Re: Taxiway Improvements
Watertown Regional Airport
Watertown, South Dakota
AIP #3-46-0058-047/048-2025
Helms #A-9070

ADDENDUM NUMBER 1

The following modifications are made to the plans and specifications for the Taxiway Improvements Project, Watertown Regional Airport:

TAXIWAY A/C INTERSECTION
STA: 416+50 TO 423+00
TAXIWAY IMPROVEMENTS
WATERTOWN REGIONAL AIRPORT
WATERTOWN, SOUTH DAKOTA

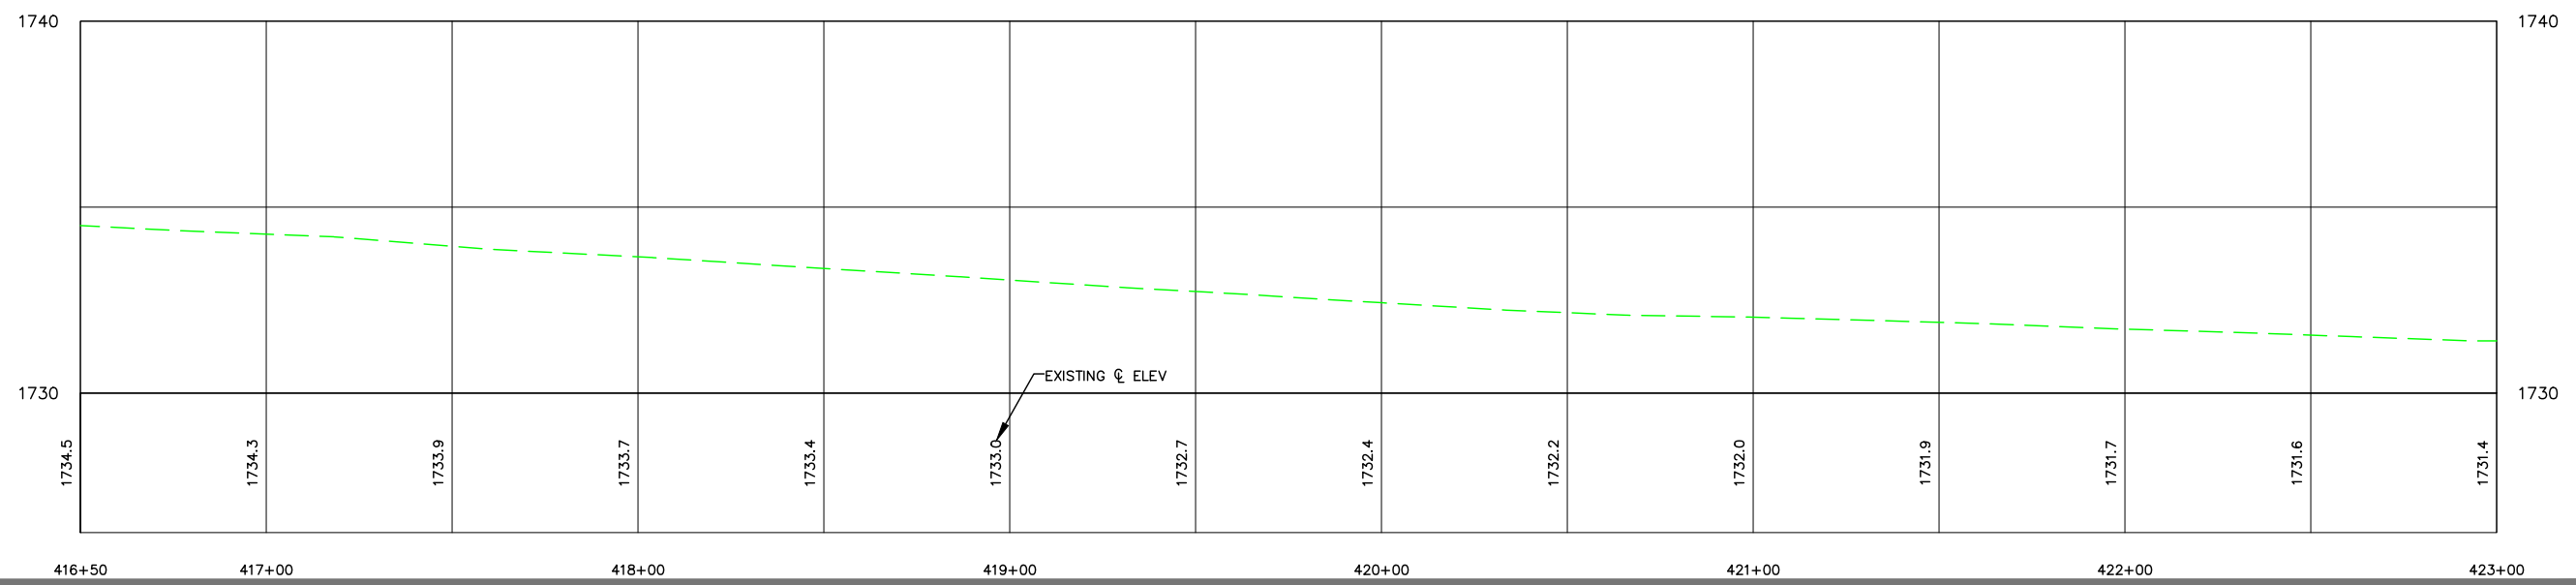
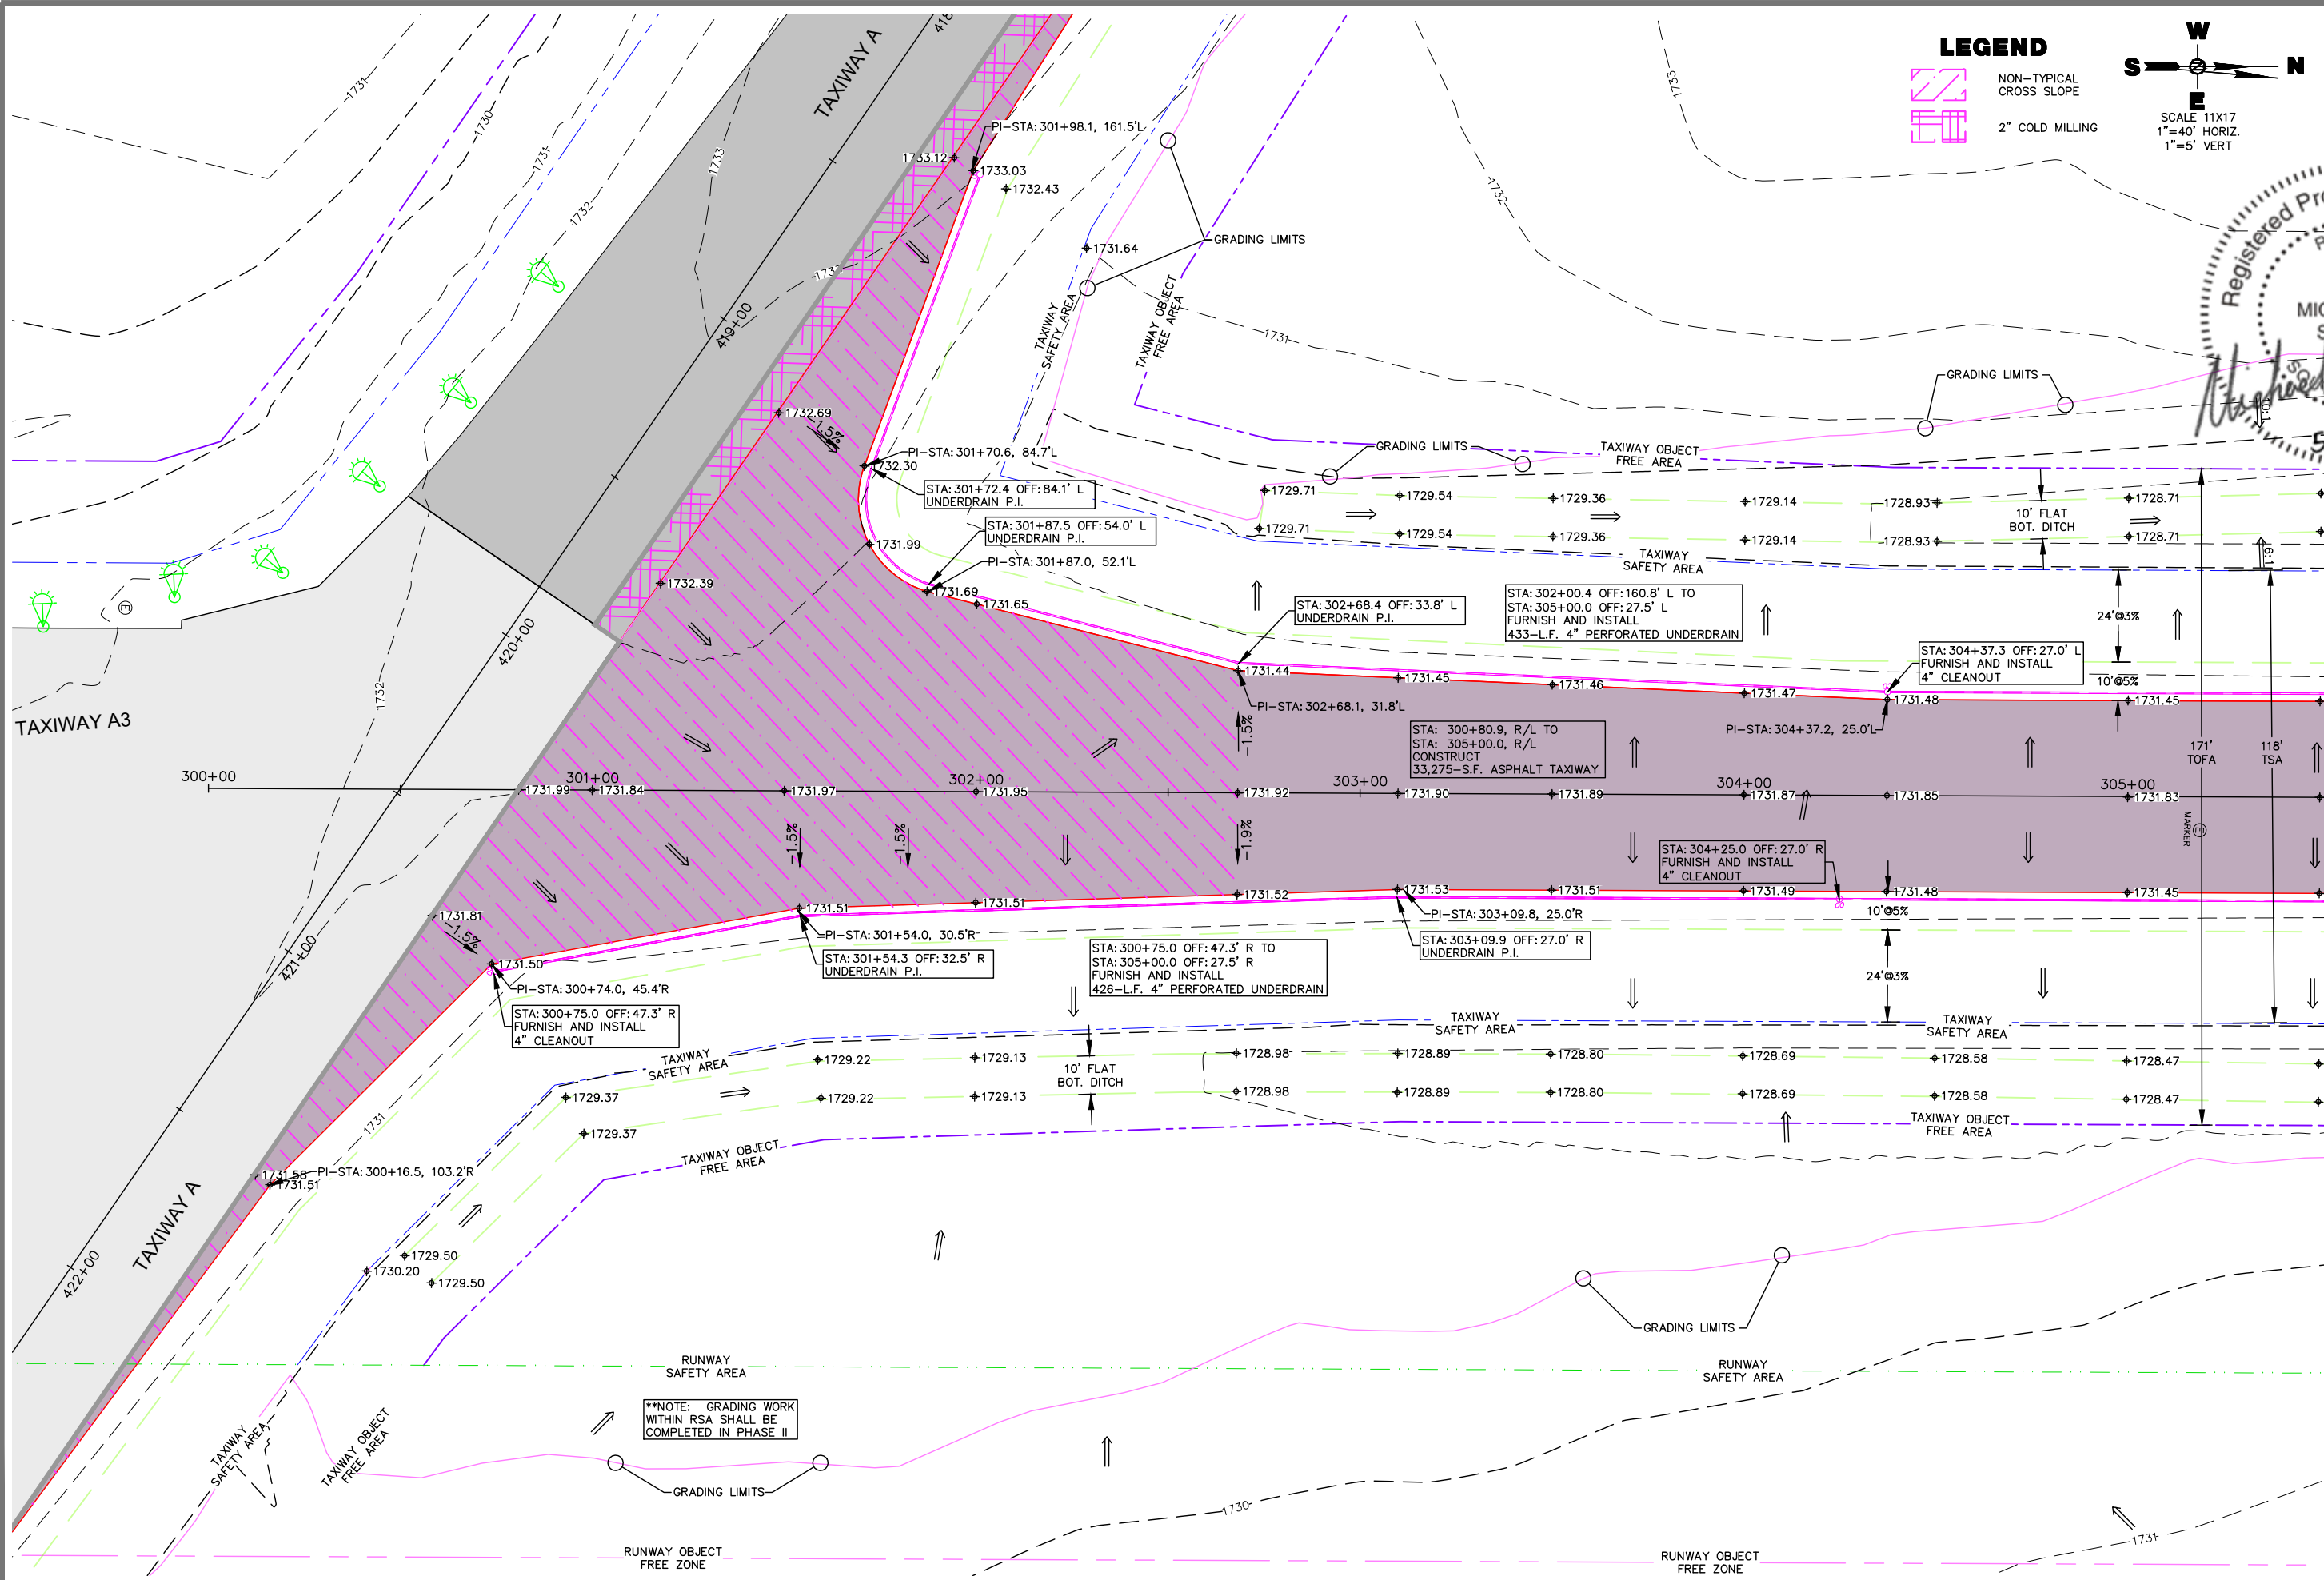
9. Taxiway A/C Intersection, Sheet 28, delete in its entirety and replaced with the attached Sheet.

Labeled the Runway Safety Area and Runway Obstacle Free Zone.

TAXIWAY C PLAN VIEW
STA: 300+00 TO 305+00
TAXIWAY IMPROVEMENTS
WATERTOWN REGIONAL AIRPORT
WATERTOWN, SOUTH DAKOTA

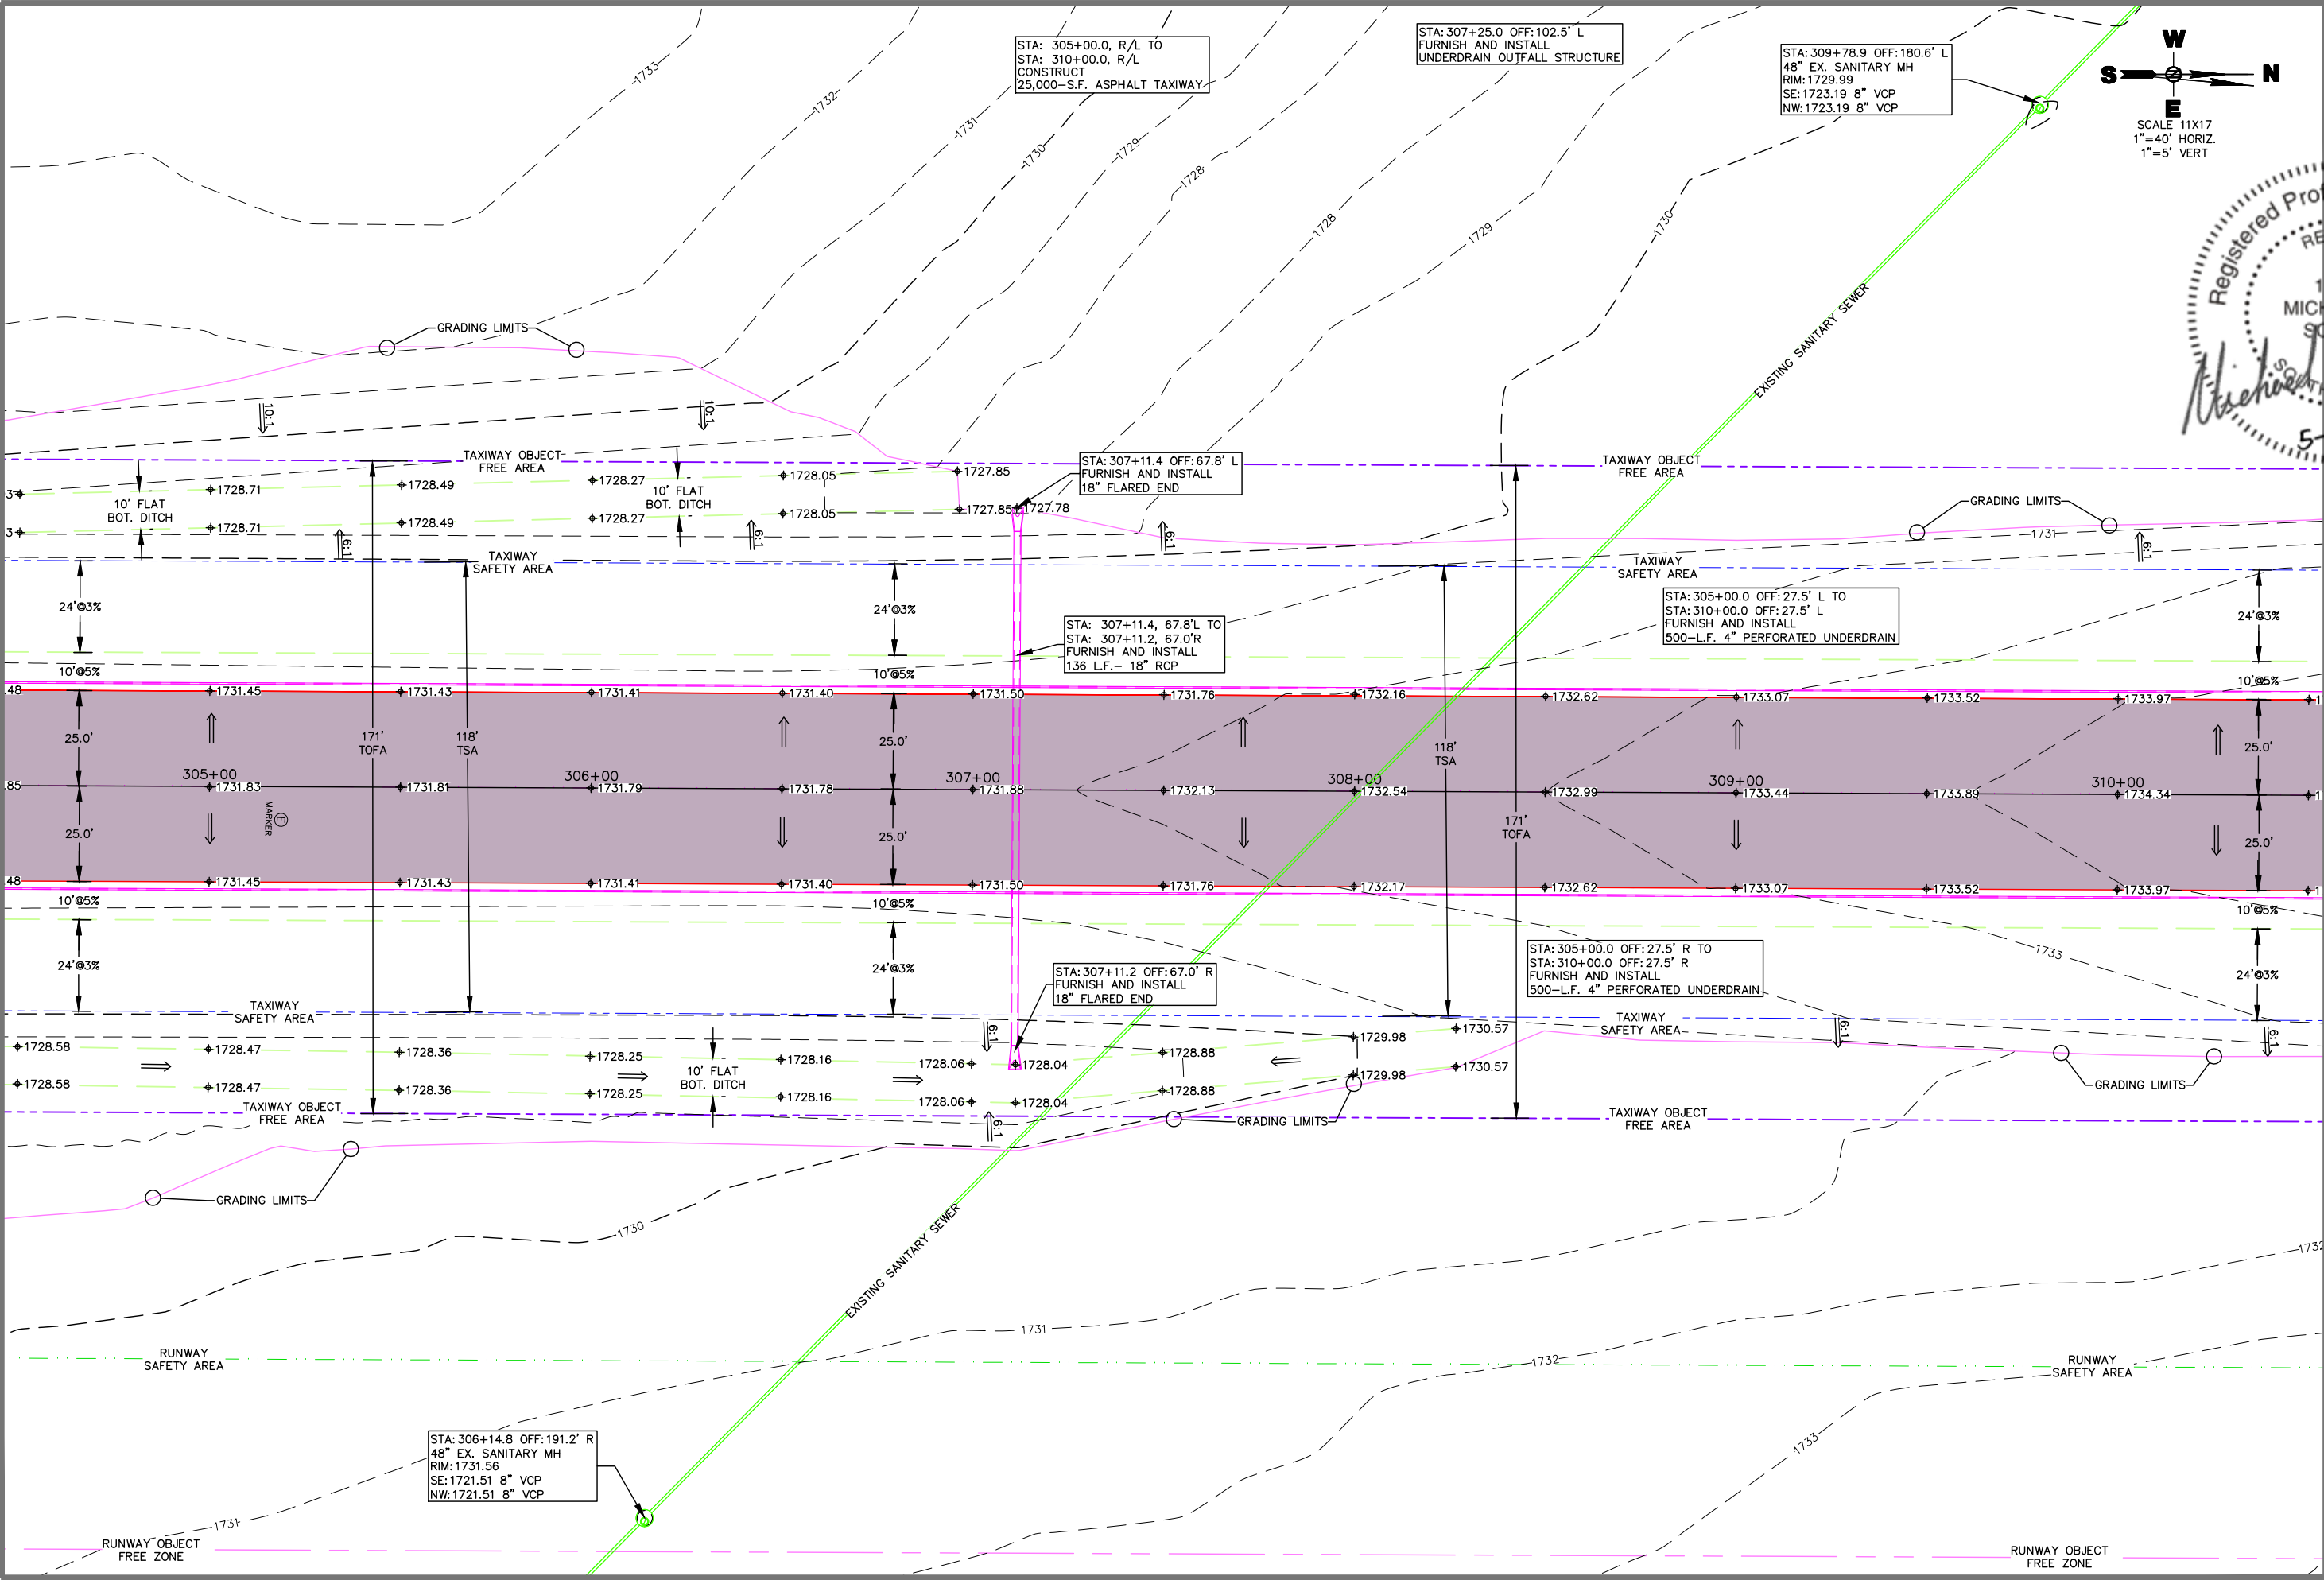
10. Taxiway C Plan View, Sheets 29, 31, 33, delete in their entirety and replaced with the attached Sheets.

Labeled the Runway Safety Area and Runway Obstacle Free Zone.
